Access Compliance Report

Public Rights-of-Way

(Curb Ramps)

Intersection ID: 11449	Main Street: MAYWOOD_DR	Cross Street: SHAMROCK_DR	Location: E
ADA ID: 2076553B478D	Ramp Type: PerpDiag	Initial Pass/Fail: Fail	Overall Compliance: No
			Severity Score: 26.25

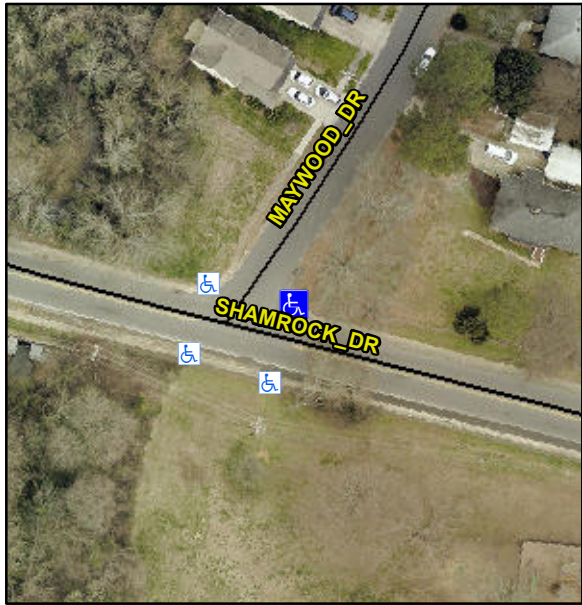
Codes/Mitigation Info/Possible Solution		Field Measurements/Component Compliance								
	Possible Solutions:	Remove & Replace Curb Ramp With Two New Directional Ramps or Equivalent.		Compliance	Description	Data	Compliance	Description	Data	
	Surveyor Notes:	N/A	PROW/ADA:	Not Found, R304.2.2, R304.5.3	N/A	Ramp Length (in)	46.0	No	Ramp Slope (%)	13.2
					Yes	Ramp Width (in)	48.0	No	Ramp XSlope (%)	2.4
					N/A	Flare Type LT	N/A	N/A	Flare Type RT	N/A
					N/A	Flare Slope LT (%)	N/A	N/A	Flare Slope RT (%)	N/A
	Total Cost:	\$	3200.00	N/A	Flare Traversable LT?	N/A	N/A	Flare Traversable RT?	N/A	
				N/A	Landing Length (in)	N/A	N/A	DWS Provided?	N/A	
				N/A	Landing Width (in)	N/A	N/A	DWS Contrast?	N/A	
				N/A	Landing Slope (%)	N/A	N/A	DWS Length (in)	N/A	
				N/A	Landing X Slope (%)	N/A	N/A	DWS Full Width?	N/A	
N/A				Landing Curb? (Y/N)	N/A	N/A	DWS Offset (in)	N/A		
N/A				Shared Landing?	N/A					
N/A				Gutter Ponding?	N/A	N/A	Gutter Slope (%)	N/A
